SUBJECT: Forwards suppl info re 941014 request for relief to
 implement temporary non-code repair of leaking section of
 pipe in chemical & vol control sys at facility, in response
 to NRC 941021 telcon request.

H. B. ROBINSON STEAM ELECTRIC PLANT, UNIT NO. 2
DOCKET NO. 50-261/LICENSE NO. DPR-23
SUPPLEMENTAL INFORMATION RELATED TO REQUEST FOR RELIEF TO
IMPLEMENT A TEMPORARY NON-CODE REPAIR

ENCLOSURE
SUPPLEMENTAL INFORMATION RELATED TO THE OCTOBER 14, 1994 REQUEST
FOR RELIEF TO IMPLEMENT A TEMPORARY NON-CODE REPAIR

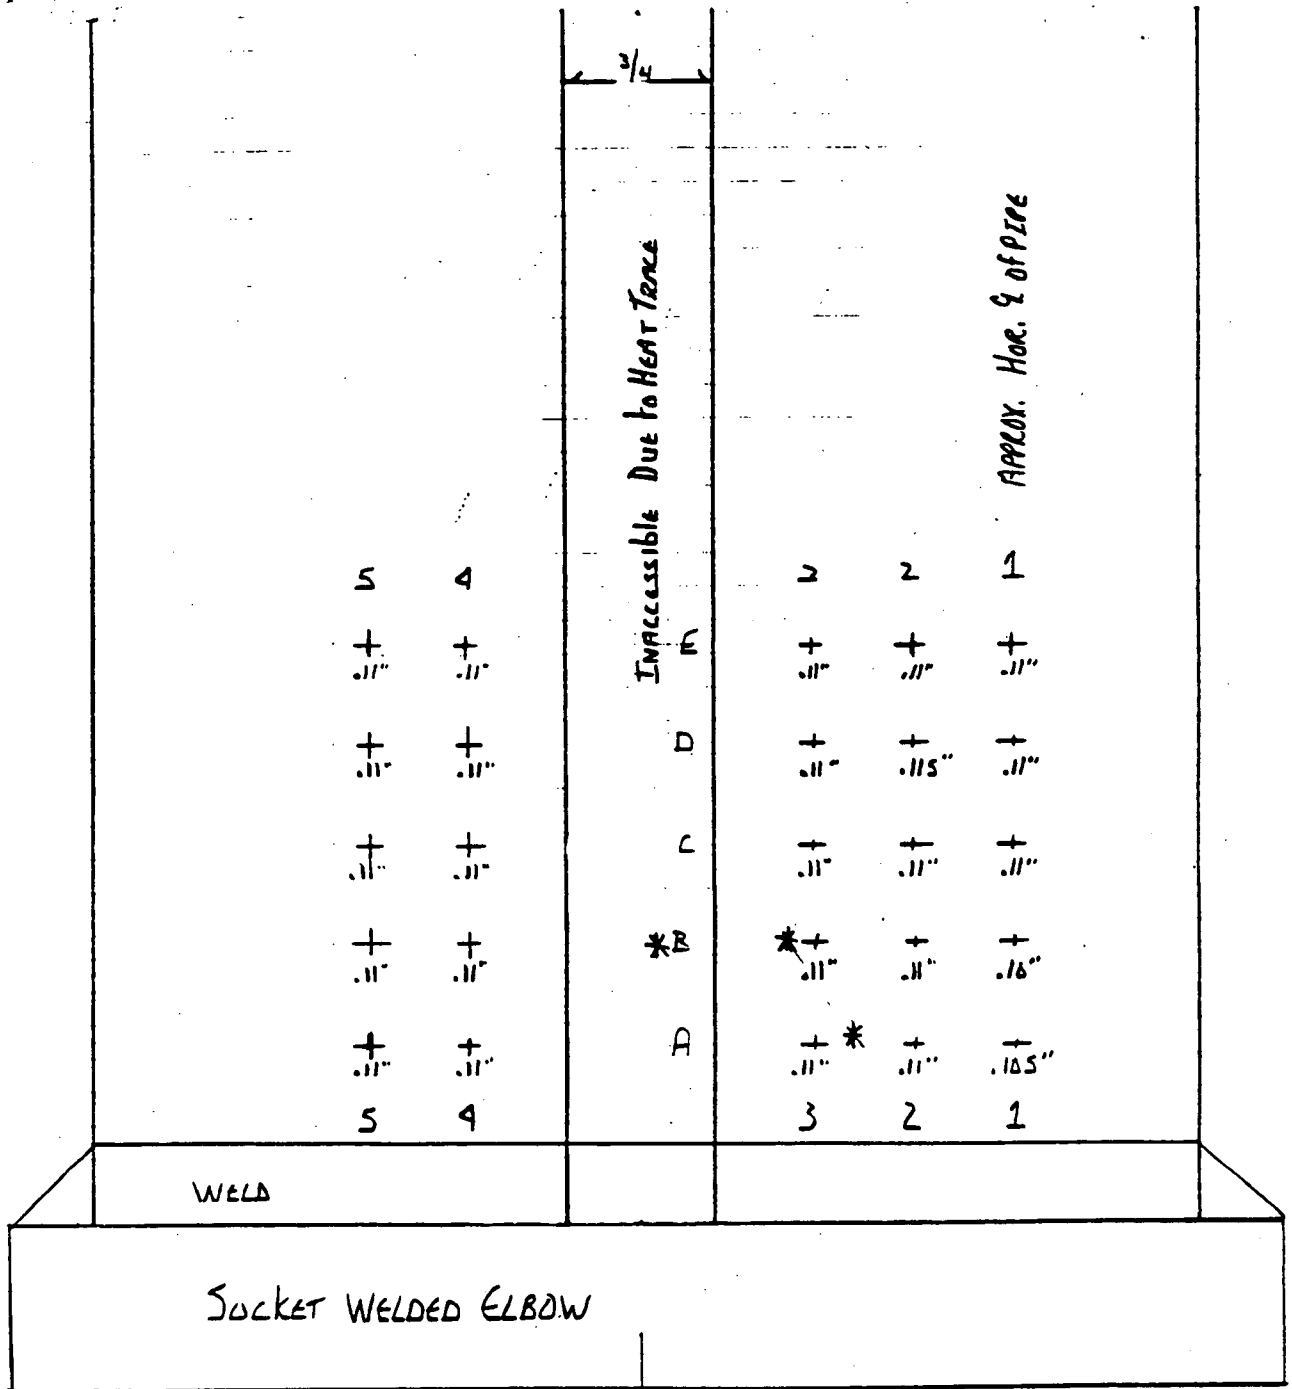
- (1) Provide a plot of the site that was ultrasonically tested.

A plot showing the site that was ultrasonically tested is attached.
